Ref: WBC email Date: 13 April 2026, Development Management & Compliance

Revised Plans Consultation Application Number: 253074

A quick review of the resubmitted revised Revised Developer's Drainage Strategy Report reveals nothing has materially changed, viz: Fourth comments 1 to 12 follow:

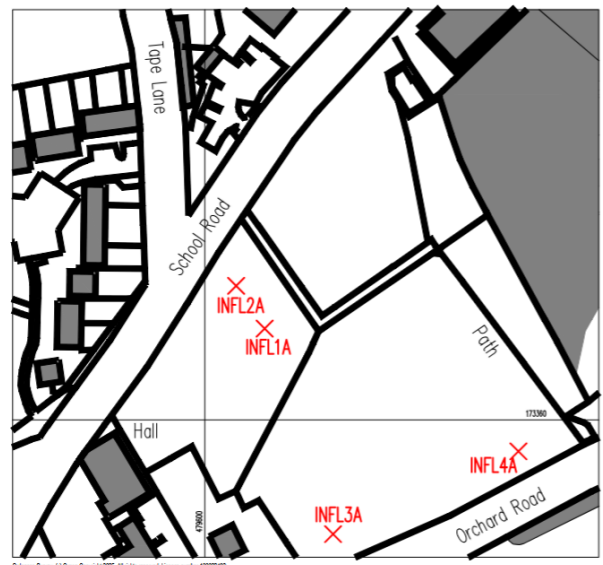
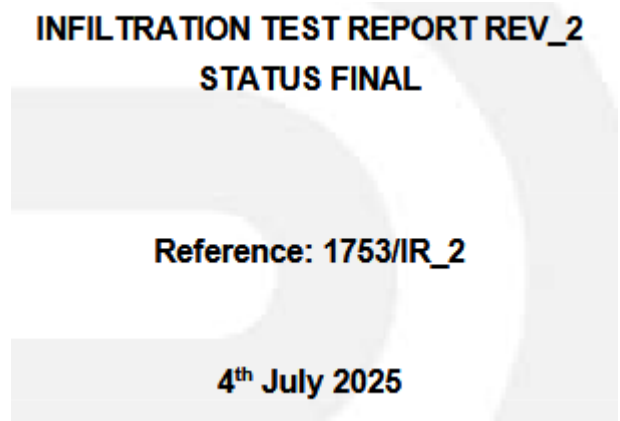
(10) Trial Test Pit Locations: In this revised, Revised, Drainage Strategy Report WBC Date Received: 01/05/2025 (but STATUS FINAL date 4th July 2025), the Developer has added an existing map showing preferentially selected, revised, reannotated trial pit locations from the Drainage Strategy Report which provides no new information, viz see screenshot below:

This shows test pits reannotated for the Drainage Strategy as:

INFL1A (originally test INFL1)

INLF2A (originally test INLF3)

INLF3A (originally test INLF5)

INLF4A (originally test INLF6)

INLF4 the poor-infiltration-result test pit located in the flood prone ponding area of the west field, just north of Willowmead’s boundary fence (see 2023 April photo), has been deleted from the map and not included for use in infiltration calculations based on this unrepresentative “summer” test data.

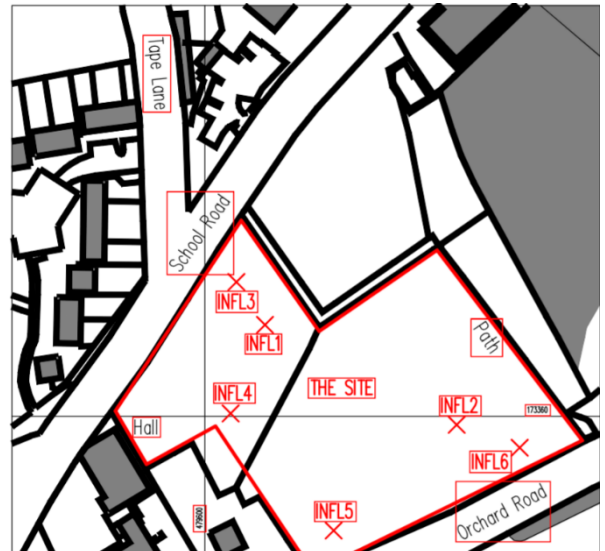
INFL2 2.24×10^{-6} has also been removed from the map. For easy comparison, see screenshot of the trial pit locations from the Infiltration Report – this test pit location and nomenclature discrepancy is highlighted in original comments made to WBC Planning Date Received: 27/01/2026.

Seasonally realistic February/March retests to obtain more representative infiltration values for the whole site, must include pits near the flood prone INFL4 area, and at the north of the east field near the school, where the archaeologists could not fully excavate their trench as intended due to the speed of water ingress, viz: “Trench 8 (Figs 2, 5 and 6: Pls 13-14) “Initially hand dug for the first 0.40m, the water influx was too rapid to allow digging by hand...”

Importantly, neither map shows a trial or test pit dug near or next to this neighbouring soggy, marshy area north of Vine Cottage – this would be a good place to dig a “wet” test pit or two!
